# Access Compliance Report

## Public Rights-of-Way

Intersection ID: 14857	Main Street: ATHERTON_ST	Cross Street: SOUTH_BV	Location: S
ADA ID: CFB2C55DD619	Ramp Type: Perp	Initial Pass/Fail: Fail	Overall Compliance: No
Severity Score: 10			
Codes/Mitigation Info/Possible Solution		Field Measurements/Component Compliance

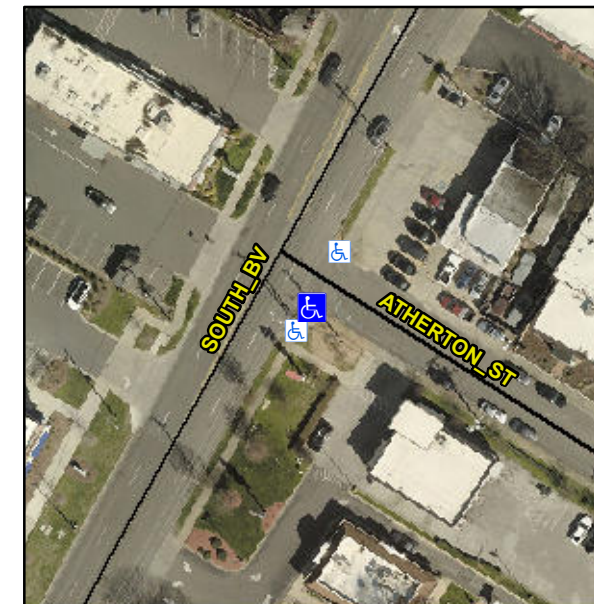
**Remove & Replace Entire Ramp.**

**R304.5.1, R304.5.3**

Compliance	Description	Data	Compliance	Description	Data
N/A	Ramp Length (in)	77.0	Yes	Ramp Slope (%)	6.5
No	Ramp Width (in)	37.0	No	Ramp XSlope (%)	2.5
N/A	Flare Type LT	N/A	N/A	Flare Type RT	N/A
N/A	Flare Slope LT (%)	N/A	N/A	Flare Slope RT (%)	N/A
N/A	Flare Traversable LT?	N/A	N/A	Flare Traversable RT?	N/A
N/A	Landing Length (in)	N/A	N/A	DWS Provided?	N/A
N/A	Landing Width (in)	N/A	N/A	DWS Contrast?	N/A
N/A	Landing Slope (%)	N/A	N/A	DWS Length (in)	N/A
N/A	Landing X Slope (%)	N/A	N/A	DWS Full Width?	N/A
N/A	Landing Curb? (Y/N)	N/A	N/A	DWS Offset (in)	N/A
N/A	Shared Landing?	N/A			
N/A	Gutter Ponding?	N/A	N/A	Gutter Slope (%)	N/A
N/A	Gutter Lip Ht (in)	N/A	N/A	Gutter X Slope (%)	N/A
N/A	Painted X Walk1?	No	N/A	Painted X Walk2?	N/A
	X Walk 1 Direction	To NE		X Walk 2 Direction	N/A
N/A	X Walk 1 Width (in)	N/A	N/A	X Walk 2 Width (in)	N/A
	X Walk 1 Slope (%)	6.5		X Walk 2 Slope (%)	N/A
	X Walk 1 X Slope (%)	3.6		X Walk 2 X Slope (%)	N/A
